Access Compliance Report

Public Rights-of-Way

(Curb Ramps)

Intersection ID: 12285	Main Street: E_TRADE_ST	Cross Street: N_TRYON_ST	Location: N
ADA ID: 032A2275471E	Ramp Type: Perp	Initial Pass/Fail: Pass	Overall Compliance: No
Severity Score: 2.75			
Codes/Mitigation Info/Possible Solution		Field Measurements/Component Compliance

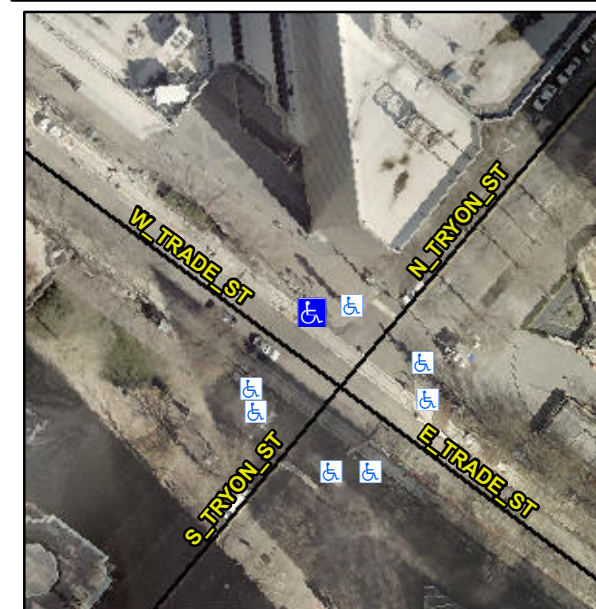
Not Found, R304.5.3, R304.2.3

Compliance	Description	Data	Compliance	Description	Data
N/A	Ramp Length (in)	24.0	Yes	Ramp Slope (%)	7.2
Yes	Ramp Width (in)	48.0	No	Ramp XSlope (%)	3.2
N/A	Flare Type LT	Sloped	N/A	Flare Type RT	N/A
N/A	Flare Slope LT (%)	5.5	No	Flare Slope RT (%)	11.2
N/A	Flare Traversable LT?	Yes	N/A	Flare Traversable RT?	Yes
Yes	Landing Length (in)	60.0	Yes	DWS Provided?	Yes
Yes	Landing Width (in)	60.0	Yes	DWS Contrast?	Yes
Yes	Landing Slope (%)	1.6	Yes	DWS Length (in)	24.0
Yes	Landing X Slope (%)	0.5	Yes	DWS Full Width?	Yes
N/A	Landing Curb? (Y/N)	No	Yes	DWS Offset (in)	0.0
N/A	Shared Landing?	No			
Yes	Gutter Ponding?	No	Yes	Gutter Slope (%)	0.4
Yes	Gutter Lip Ht (in)	0.0	Yes	Gutter X Slope (%)	0.9
N/A	Painted X Walk1?	Yes	N/A	Painted X Walk2?	N/A
	X Walk 1 Direction	To SW		X Walk 2 Direction	N/A
N/A	X Walk 1 Width (in)	114.0	N/A	X Walk 2 Width (in)	N/A
	X Walk 1 Slope (%)	0.4		X Walk 2 Slope (%)	N/A
	X Walk 1 X Slope (%)	0.9		X Walk 2 X Slope (%)	N/A

Remove & Replace Entire Ramp.
